Development Application No: DEV2024/1571

Property Location: Nirimba Drive, Nirimba (Lot 8 on SP334576)

Application Description: Material Change of Use for Child Care Centre

Subject: Response to EDQ's Further Issues Letter – Traffic Matters

Vehicle Tracking Diagram – Small Rigid Vehicle

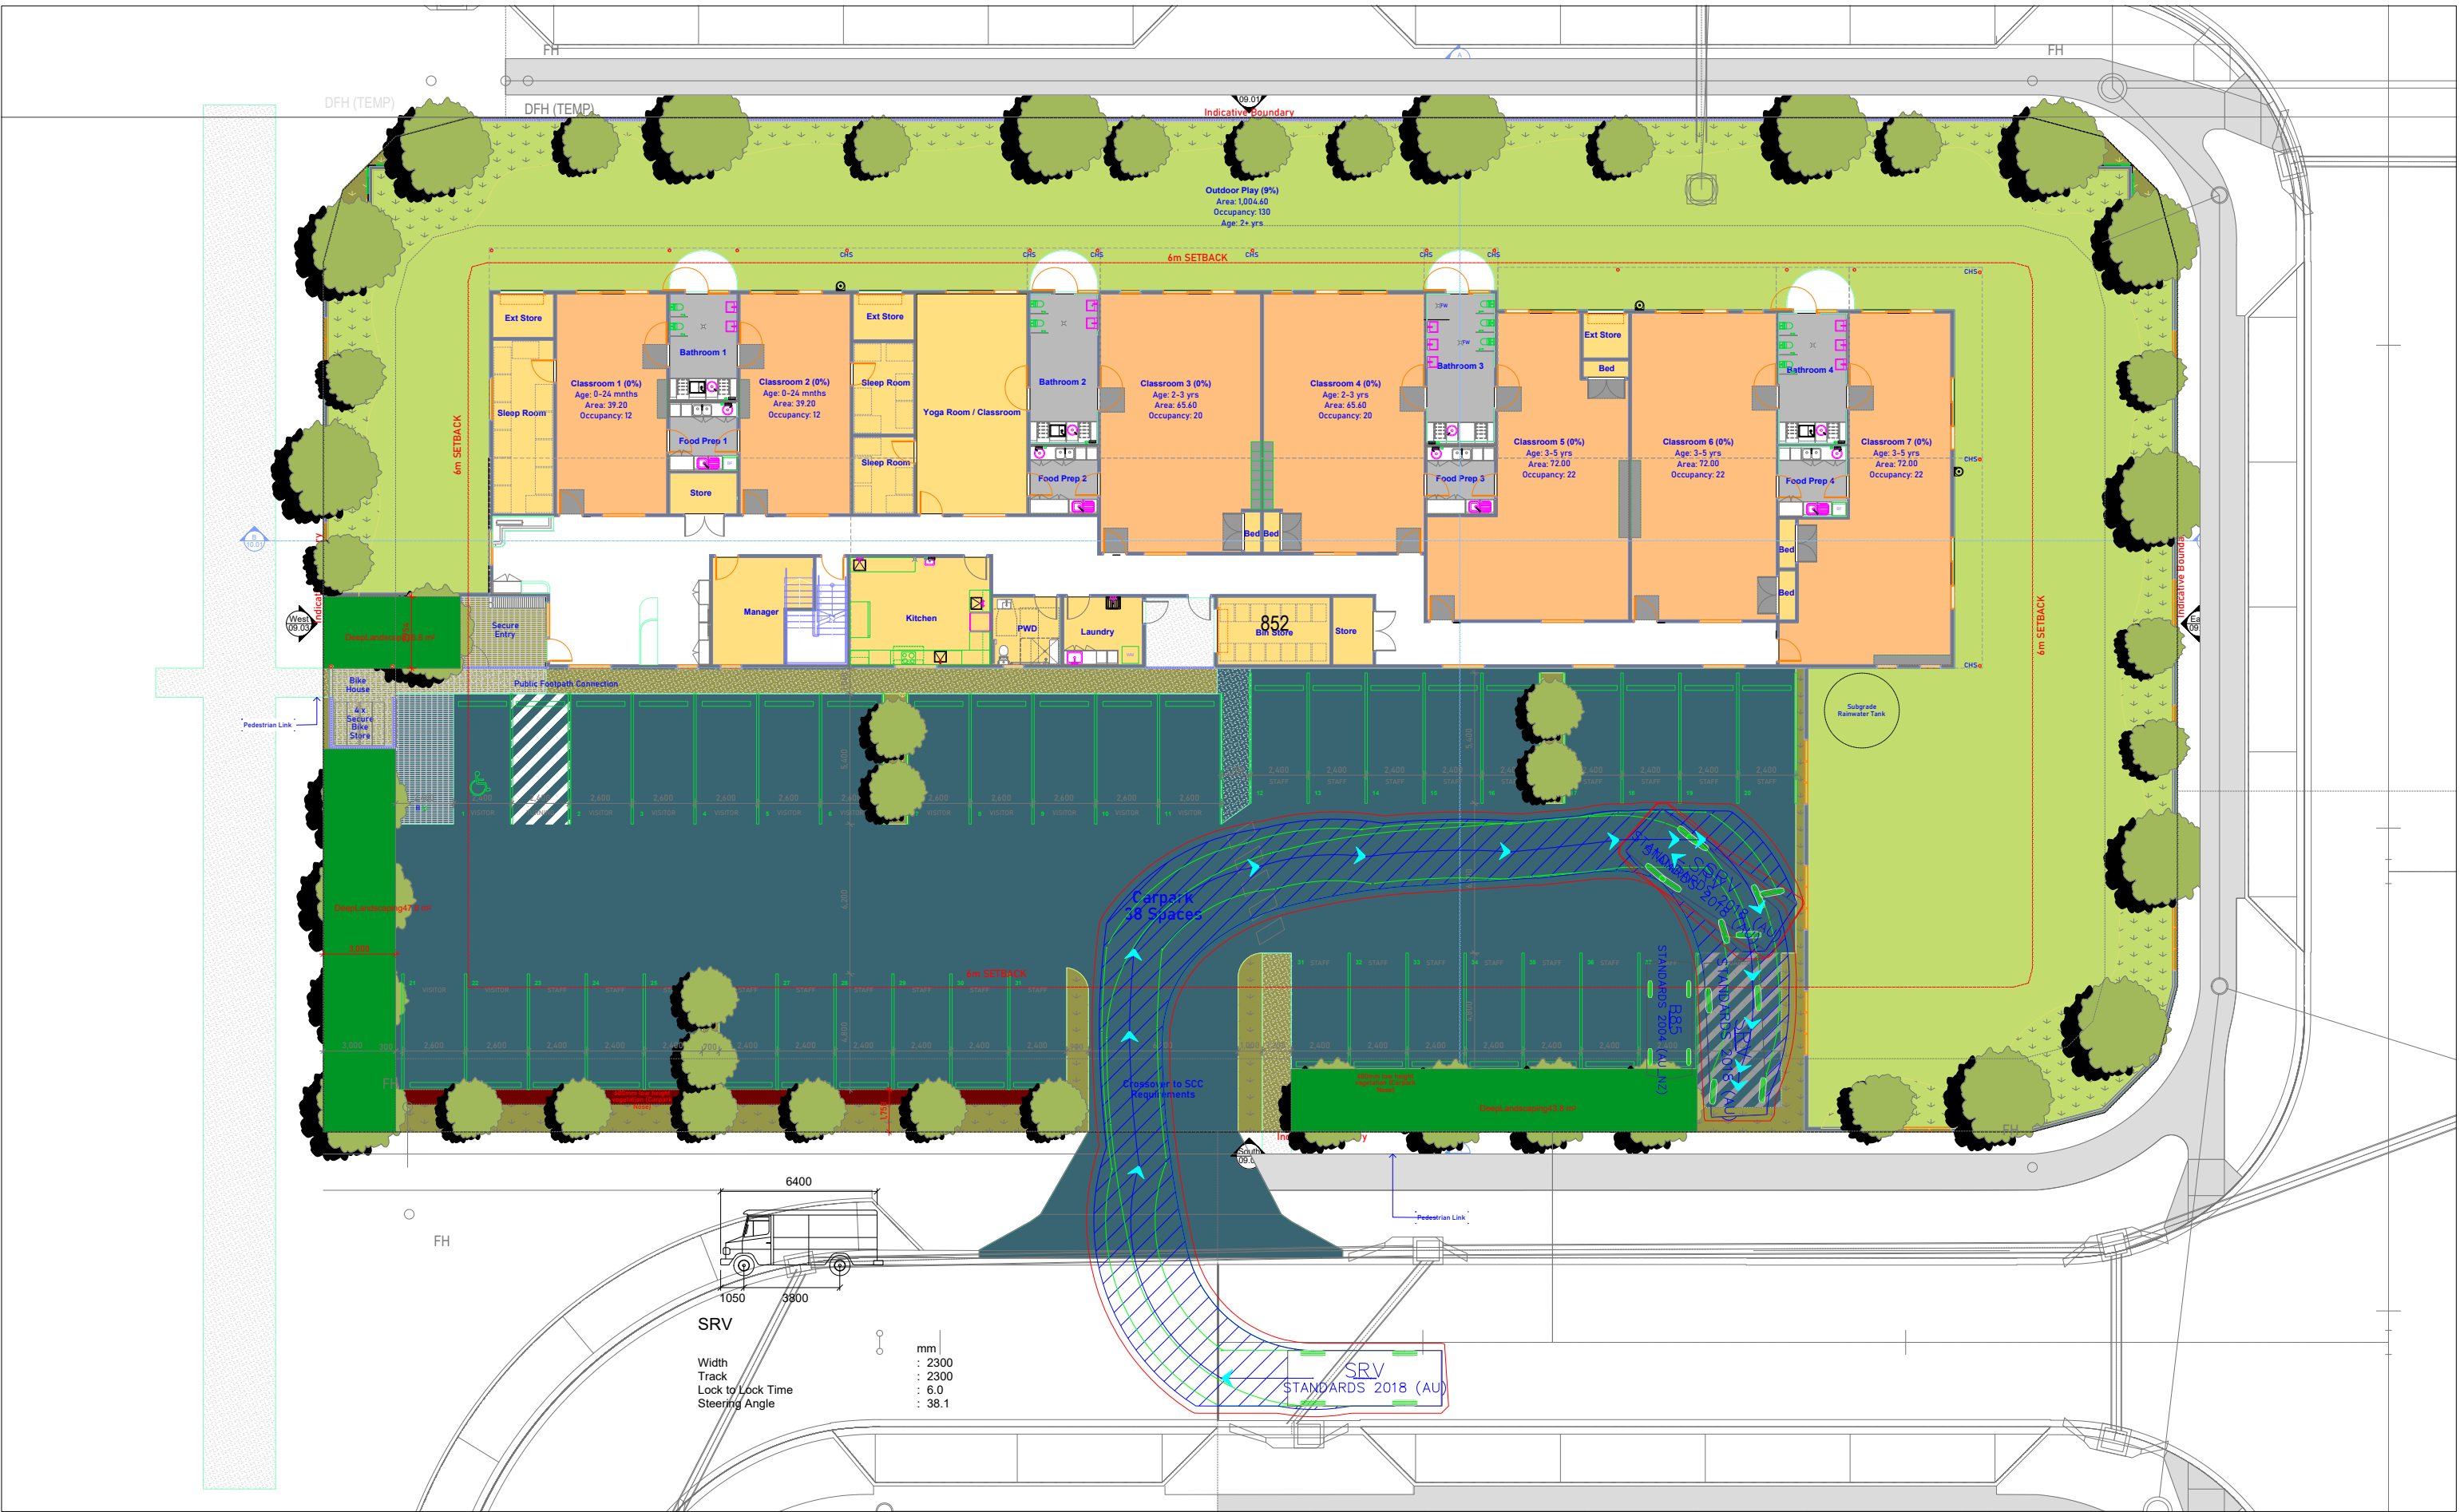
c) Swept path drawings have not demonstrated that the service vehicle can enter and exit the site in a forward gear. Additional manoeuvring area and revised swept path drawings are to be provided to demonstrate service vehicles can enter and exit the site in a forward gear.

Notwithstanding the above, the vehicle tracking diagrams included as **Attachment 3** demonstrate a larger service vehicle (a 6.4m long Small Rigid Vehicle (SRV)) entering the site, accessing the service bay, and exiting the site in a forward direction.
